Proposal for Supplement 3 to the 02 series of amendments to UN Regulation No. 53 (Installation of lighting and light- signalling devices for L₃ vehicles)

Submitted by the Working Party on Lighting and Light-Signalling*

Supplement 3 to the 02 series of amendments to UN Regulation No. 53 (Installation of lighting and light-signalling devices for L₃ vehicles)

"Annex 7

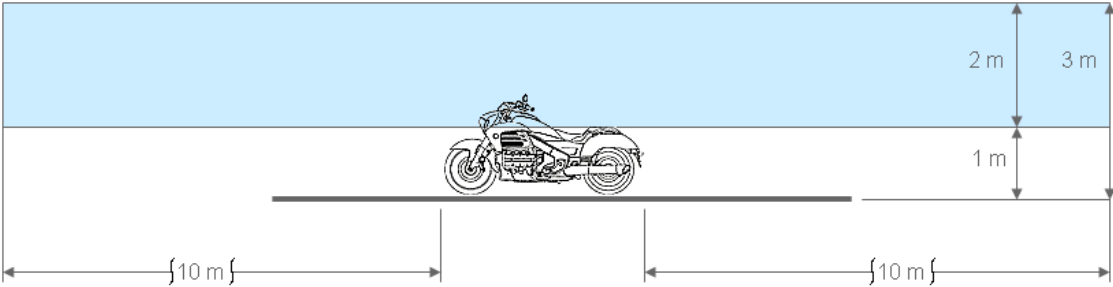
Insert a new Annex 7, to read:

Observing area towards the apparent surface of exterior courtesy lamps

Zones of observation

This drawing shows the zone from one side, the other zones are from the front, the rear and from the other side of the vehicle.

- 6.15.9.3. The technical service shall, to the satisfaction of the Type Approval Authority, perform a visual test to verify that there is no direct visibility of the apparent surface of the exterior courtesy lamps, if viewed by an observer moving on the boundary of a zone on a transverse plane 10 m from the front of the vehicle, a transverse plane 10 m from the rear of the vehicle, and two longitudinal planes 10 m from each side of the vehicle; these four planes to extend from 1 m to 3 m above and perpendicular to the ground as shown in Annex 7.
